Refer to: HNG-14/SS-22

Thank you for your letter of December 13 to Mr. Thomas O. Willett in which you requested Federal Highway Administration (FHWA) acceptance for your company's revised Type "L" MICRO=LAM laminated veneer lumber signposts as breakaway structures. Our letter of August 19, 1986, accepted the original MICRO=LAM design based upon full-scale crash testing in weak soil. In support of your current request you submitted reports dated November 1990, of tests conducted at the Southwest Research Institute. Four tests were conducted to assess the compliance of the MICRO=LAM post with a revised sawcut pattern with the breakaway requirements of the 1985 AASHTO Standard Specifications for Structural Supports for Highway Signs, Luminaires and Traffic Signals. These specifications have been adopted, with minor modifications, by the FHWA. The pendulum testing also included posts with the old sawcut design to permit comparison between the full scale and the pendulum test results.

Roadside and Geometric Design Acceptance Letter SS-22

FIGURE 1. - TYPE "L" STENPOST SAWCUT GEOMETRY

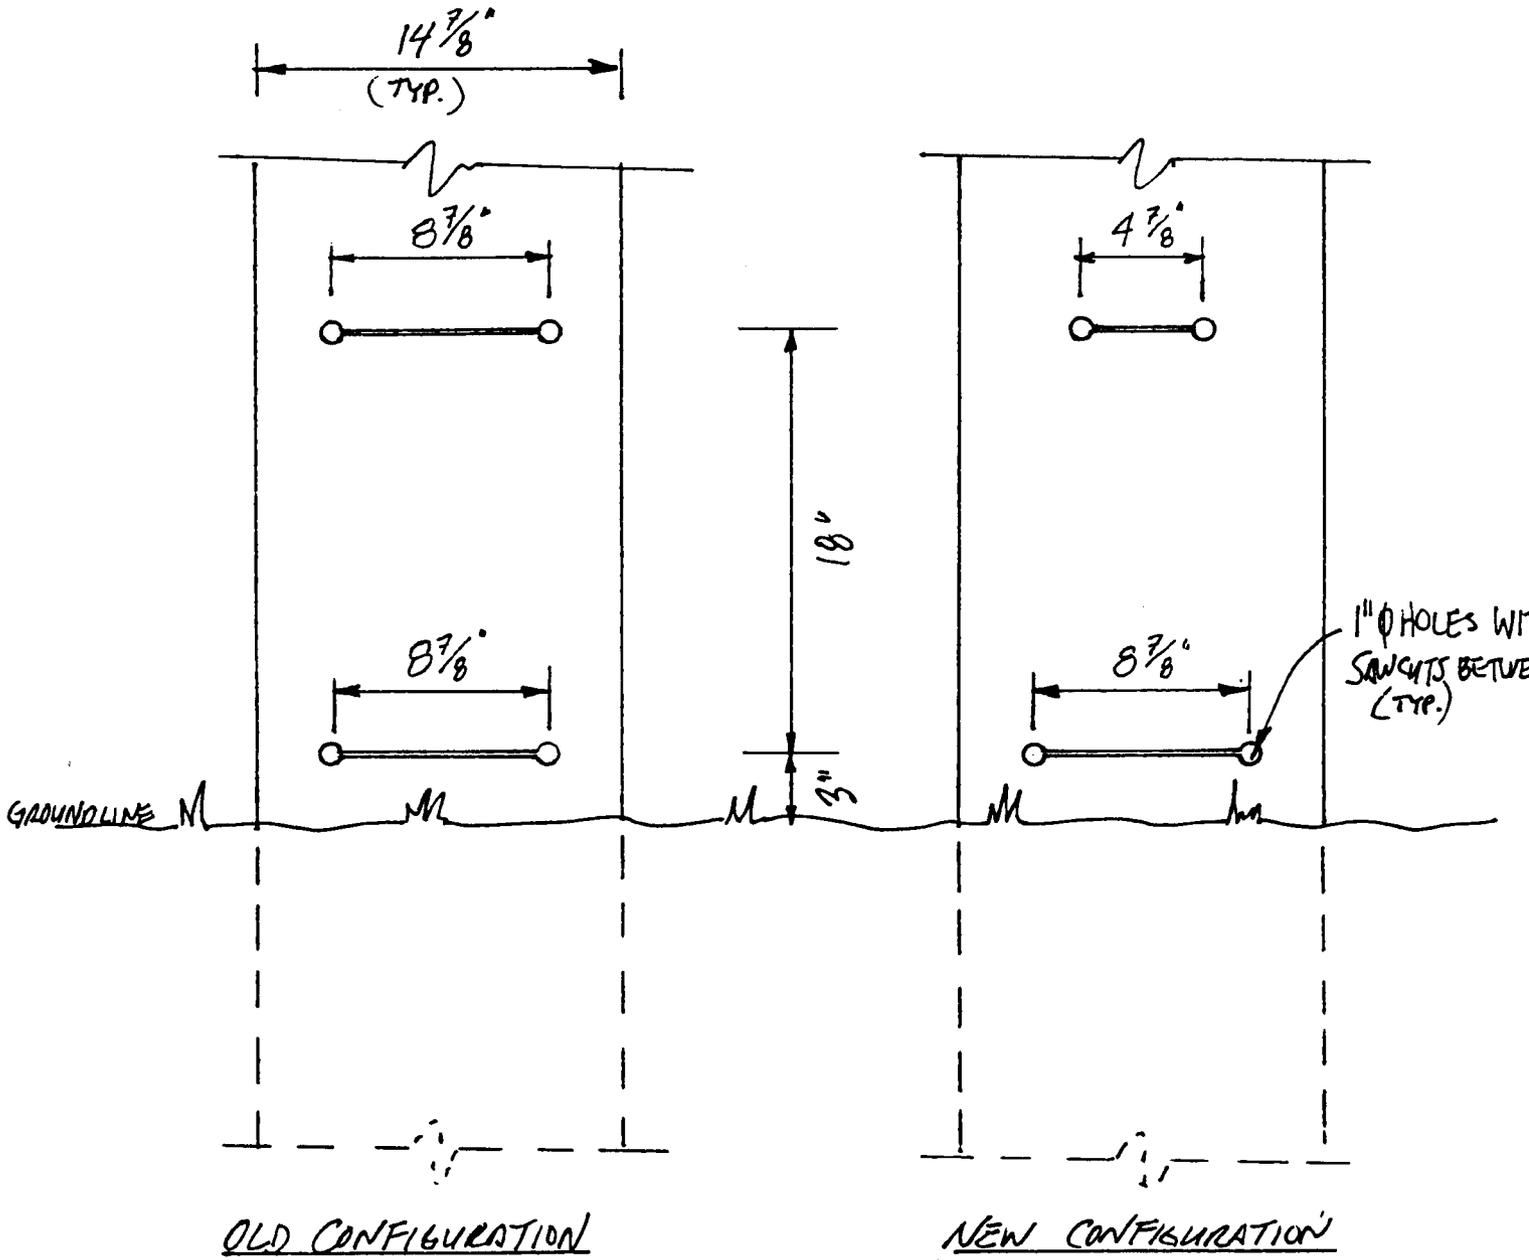
Testing was conducted using an 1,800-pound instrumented pendulum with a 10-stage crushable nose. The speed of the pendulum at impact was 20 mph (29.3 fps). Details of the tested 14 7/8 inch x 7 7/8 inch posts are shown in the enclosures. Test results are summarized below:

Test Number	TJ-10	TJ-11	TJ-12	TJ-13
Sawcut Type	Old	New	Old	New
Soil Type	Strong	Strong	Weak	Weak
Pendulum Velocity Change	7.6 fps	9.0 fps	*6.9 fps	8.2 fps
Est. 60 mph Velocity Change	7.2 fps	7.6 fps	*6.9 fps	7.4 fps
Stub Height	3.0 in	3.0 in	3.0 in	3.0 in
Weight of Test Article	319 lb	319 lb	319 lb	319 lb

The above information shows that the tested posts meet the change in velocity and stub-height requirements adopted by the FHWA. Therefore MICRO=LAM posts spaced further than 7 feet apart with the new sawcut design are acceptable for use on Federal-aid projects when requested by a State.
